The new Buenos Aires power station

C. K. Haswell, B.Sc.(Eng.), M.I.C.E.

L. Sancha, D.F.C., B.Sc.(Eng.), M.I.C.E.

FIG. 15: INSIDE THE TURBINE HALL

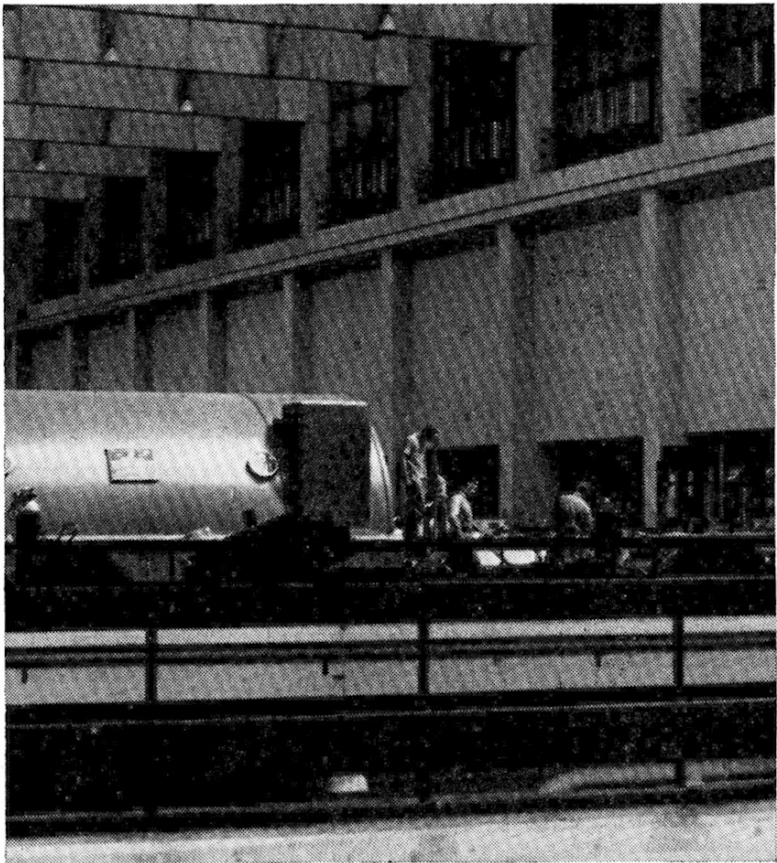
158. Turning to more detailed matters, Mr Powell paid tribute to the architectural design of the buildings, which were in many respects quite novel; regrettably, the illustrations in the Paper did less than justice to the architecture. It was also a matter of regret that the Authors were unable to show illustrations of the interior of, say, the turbine house which was most pleasing.

189. The inside of the turbine hall shown in Fig. 15 indicated the level of natural lighting without direct sunlight.

FIG. 16: WEST ELEVATION OF THE TURBINE HALL AND CIRCULAR CONTROL TOWER

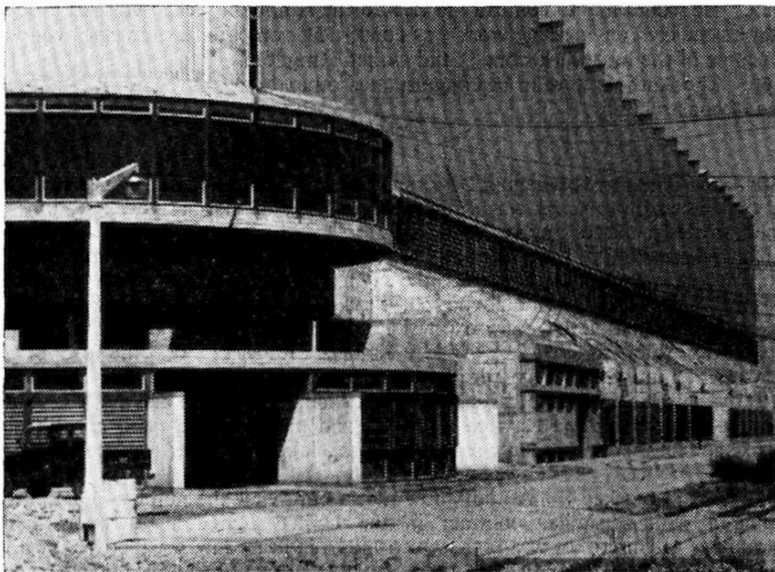
190. The turbine hall concertina is shown in Fig. 16 and the louvres referred to by Mr Johnson could be seen at the bottom of the concertina. The air flow through the louvres could also be augmented if necessary by opening the windows incorporated in the folds of the concertina. The building on the left is the circular control tower and the beginning of the administrative precinct.

FIG. 17: EAST ELEVATION OF THE BOILERHOUSE

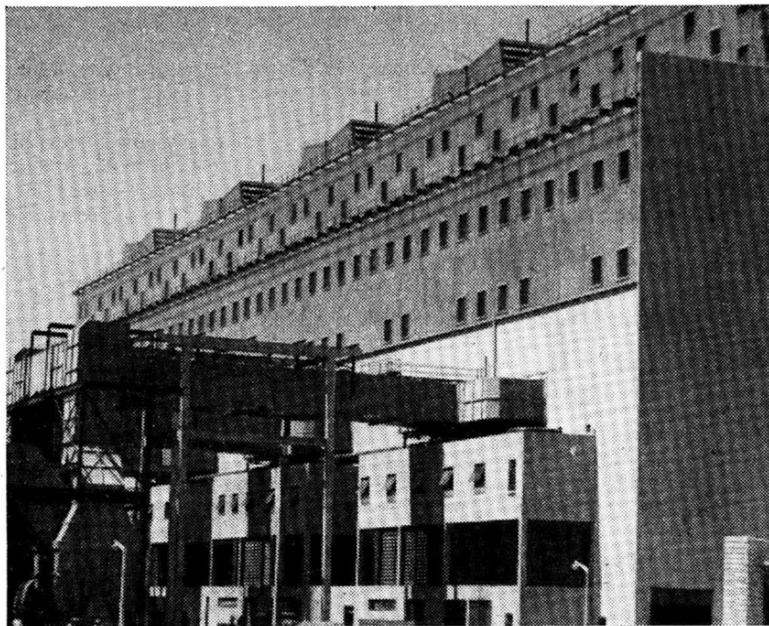
191. The east elevation of the boilerhouse is shown in Fig. 17. There the enclosing structure had to keep out the elements and provide controlled ventilation, but since the building housed massive items of plant which were virtually self-shading, no sun control was necessary. The ventilators on the roof of the boilerhouse shown in Fig. 18 were a good example of engineering needs influencing architectural form.

FIG. 19: ANCILLARY BUILDINGS GROUPED SOUTH OF THE POWERHOUSE

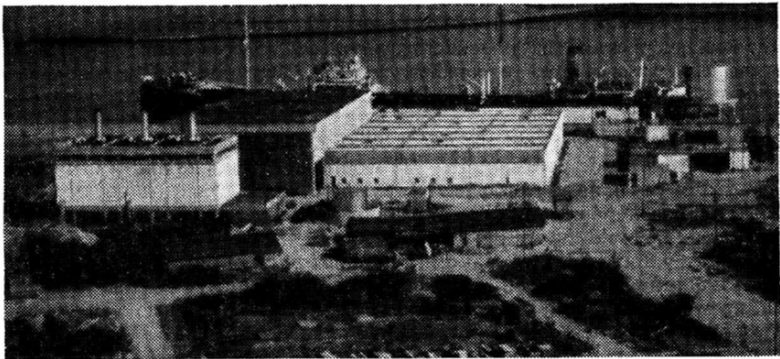
192. The layout of the group of ancillary buildings, Fig. 19, had been fixed by the Engineers, but the Architects were very pleased about it. Had the buildings been spread over the whole of the area shown, the visual effect would have been different and in her opinion, far less satisfactory. The auxiliary boilerhouse, the workshops and stores and the water treatment plant could all be seen but the cooling water pump-house did not appear as it was just to the right of the figure.
